LaSalle County Station, Units 1 and 2
Facility Operating License Nos. NPF-11 and NPF-18
NRC Docket Nos. 50-373 and 50-374

Subject: Response to Request for Additional Information License
Amendment Request for Power Uprate Operation

Attachment
Response to Request for Additional Information

Figure 4-1: Short-Term Drywell and Wetwell Pressure Response to DBA-LOCA For Power Uprate Conditions (102% of 105% Rated Thermal Power)

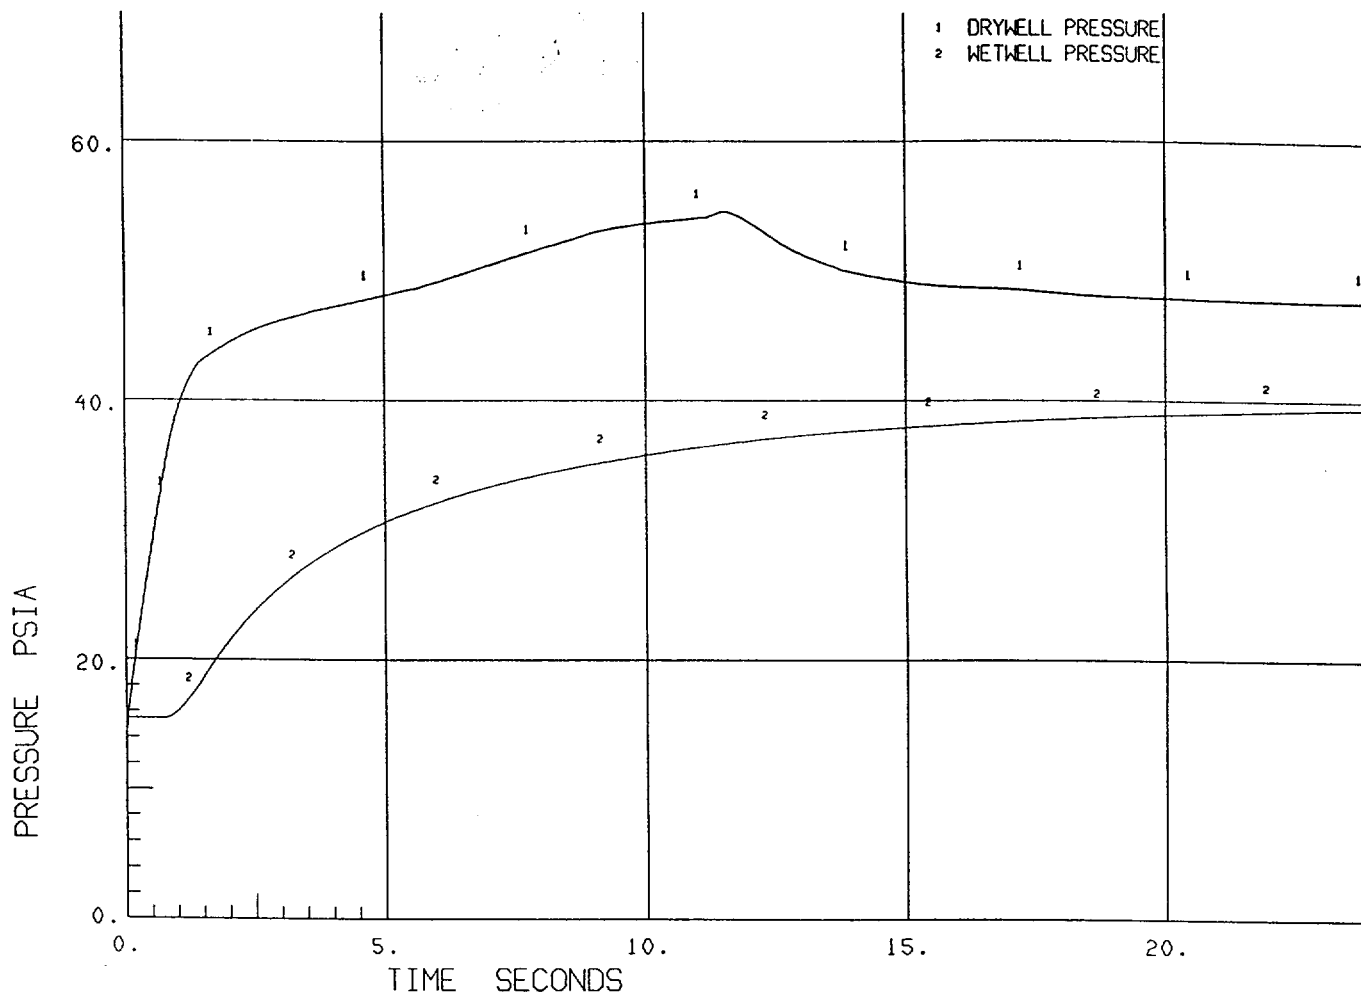
Please provide the Containment Maximum Pressure and Temperature analyses curves at uprated power.

Please refer to the attached Figures 4-1 through 4-6, for the power uprate (and re-analyzed current rated power), drywell pressures and temperatures responses for the DBA-LOCA (a double-ended break of a recirculation suction line).
